Comment 205: Figure 201-7 and Related Comment 46: Figure 201-11

G. Zimmerman / CME Consulting

2/24/2026

Figure 201-7—HS_TX PCS Transmit function block diagram

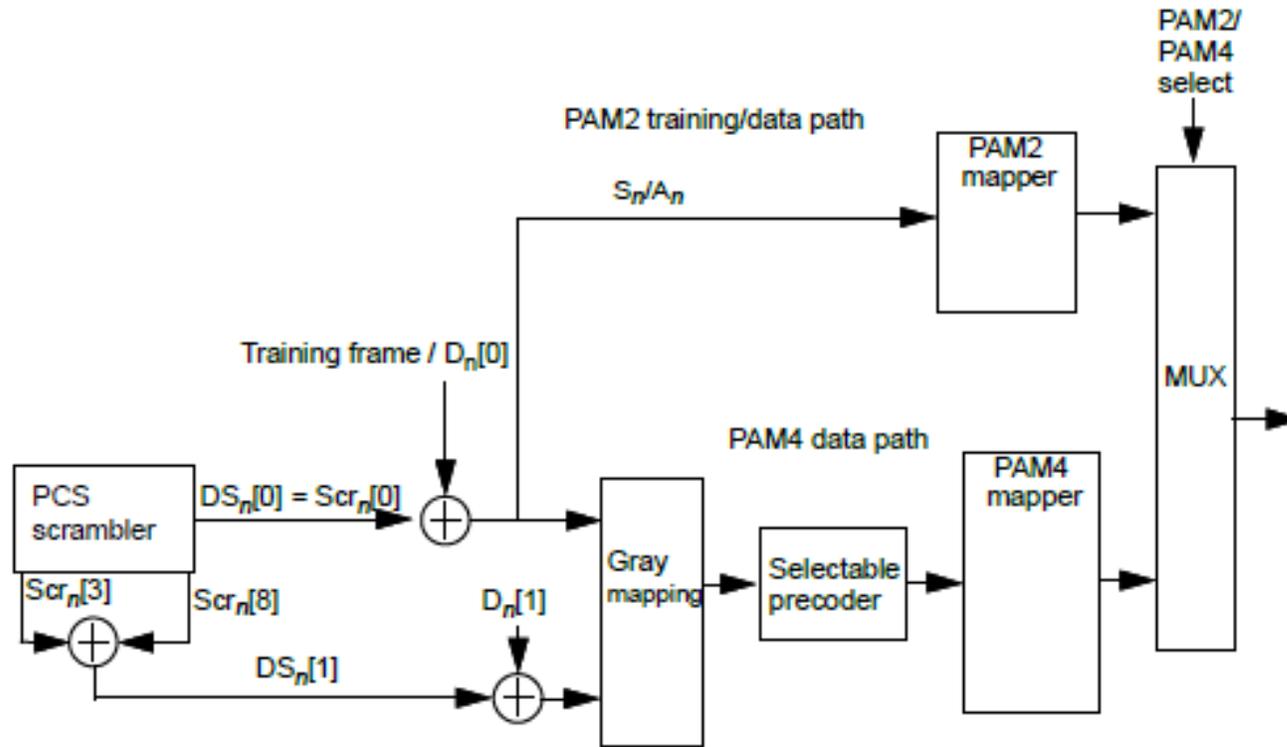
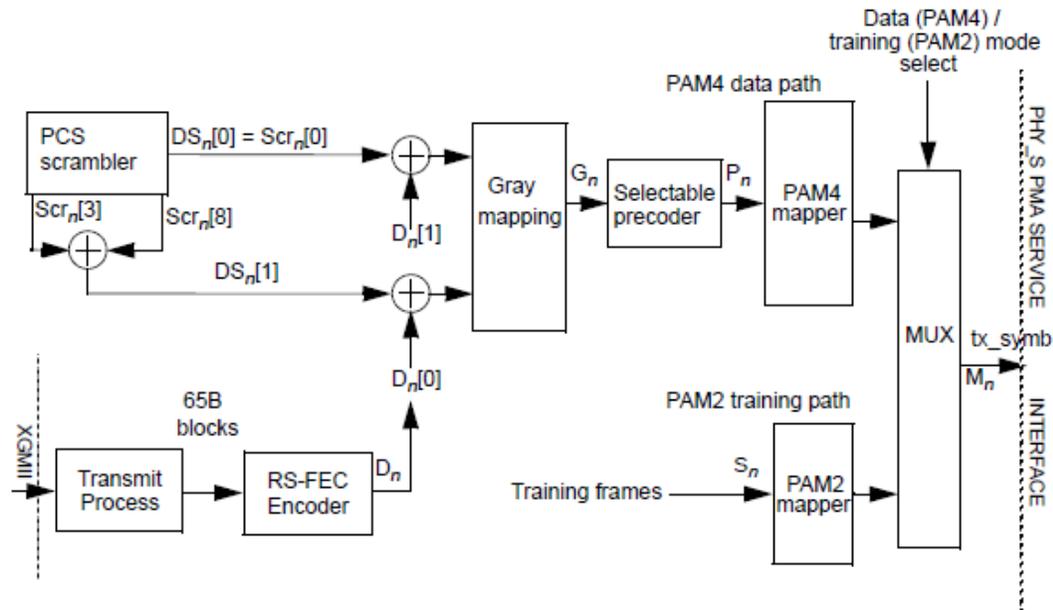
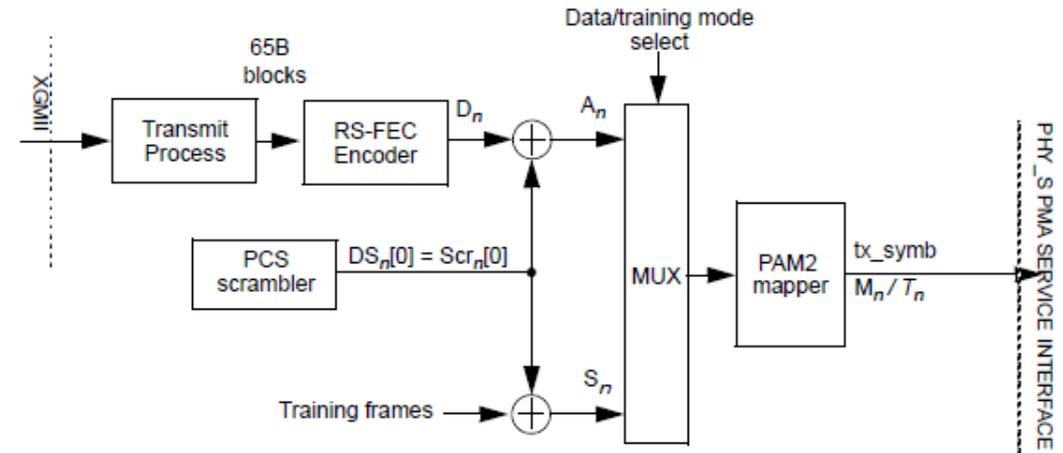
The fact that Clause 201 has both PAM2 and PAM4 PHYs creates some inconsistencies reusing Clause 149 figures for 2.5G/5G PHY Types

Existing Figure 201-7 has a number of issues.

- It mixes 2.5G/5G and 10G PCS features, which are different (2.5G/5G does not have the PAM4 path at all...),
- It is missing interfaces where signals come from
- The output is not labeled to reference other diagrams
- The Figure claims to be a 'block diagram' of the PCS Transmit, but is really only a subset of the PCS Transmit, and omits the RS-FEC encoder, and the PCS Transmit process which generates the 65B blocks from XGMII

The block diagram of HS_TX PCS Transmit functions is shown in Figure 201-7a and Figure 201-7b, replacing Figure 149-5. .

NOTE —The S_n are from the training frame, and the MUX selects the PAM2 path while in PAM2 training states.

Figure 201-7a—10Gbps HS_TX PCS Transmit function block diagram

NOTE 1 —The S_n are from the training frame, and the A_n are for the 2.5G and 5G HS_PATH.
NOTE 2 — The output of the PAM2 mapper is M_n in data mode and T_n in training mode.

Figure 201-7b—2.5Gbps and 5 Gbps HS_TX PCS Transmit function block diagram

Figure 201-11—PCS Transmit function block diagram for low speed path

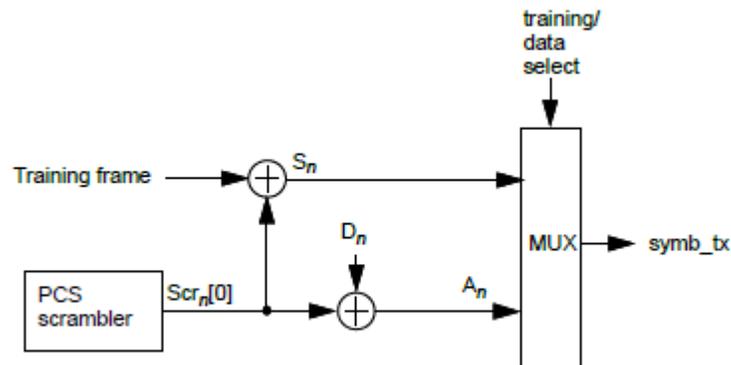
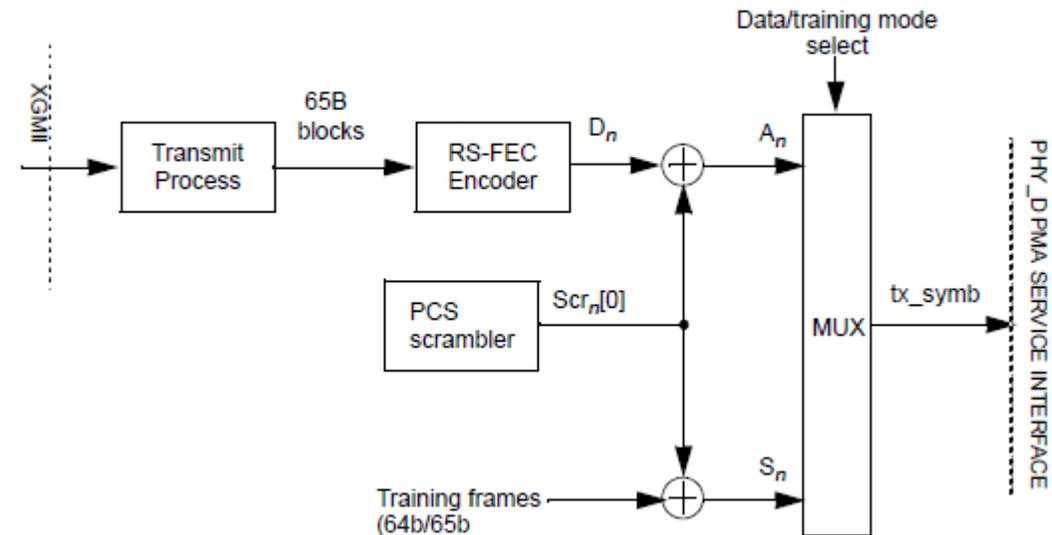
ID	Commenter	Affiliation	Subclause	Page	Line	Comment	Suggested Remedy
46	Jonsson, Ragnar	Infineon	201.4.2.3	97	32	HS_PATH in Figure 201-7	Change the handling of the "Training frame" in the figure to be consistent with how it is done in Figure 201-7

A block diagram of the low speed path PCS Transmit functions is shown in Figure 201-11.

Figure 201-11—PCS Transmit function block diagram for low speed path
